Well Name: FULL TILT 18/7 FED	Well Location: T26S / R30E / SEC 18 / TR O / 32.036815 / -103.918944	County or Parish/State: EDDY / NM
Well Number: 875H	Type of Well: OIL WELL	Allottee or Tribe Name:
Lease Number: NMNM31649	Unit or CA Name:	Unit or CA Number:
US Well Number: 3001553487	Operator: MEWBURNE OIL COMPANY

Sundry ID: 2857595

Type of Action: APD Change

Mewbourne Oil Company request that the following change be made to the Full Tilt 18/7 Fed #875H (API #30-015-53487):

FULL TILT 18/7 FED #875H

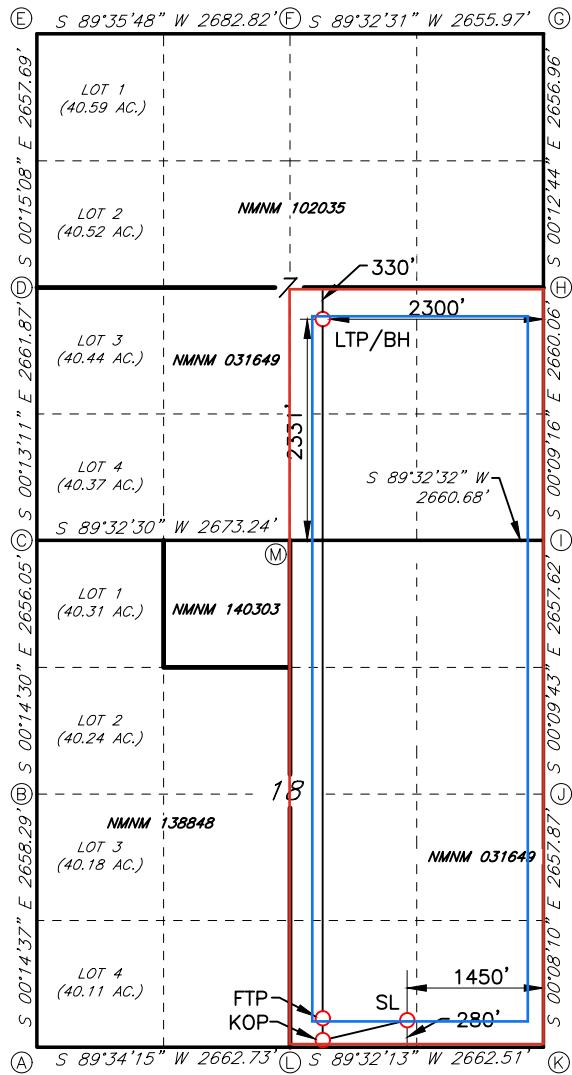
- 1. Change SHL f/ 593' FSL & 2140' FEL, Sec 18, T26S R30E, Eddy Co., NM to 280' FSL & 1450' FEL, Sec 18, T26S R30E, Eddy Co., NM.**
- 2. Change BHL f/ 2560' FSL & 2329' FEL, Sec 7, T26S R30E, Eddy Co., NM to 2331' FSL & 2300' FEL, Sec 7, T26S R30E, Eddy Co., NM**
- 3. Change pool name and code f/ RED HILLS; UPPER BONE SPRING SHALE [97900] to PURPLE SAGE; WOLFCAMP (GAS) [98220]**
- 4. Adjust casing, cement, directional plan, and drilling program as detailed in respective attachments.**

SURFACE LOCATION (SL)
280' FSL & 1450' FEL (SEC.18)
N: 377071.0 - E: 670433.9

LAST TAKE POINT/BOTTOM HOLE (LTP/BH)
2331' FSL & 2300' FEL (SEC.7)
N: 384429.0 - E: 669564.6
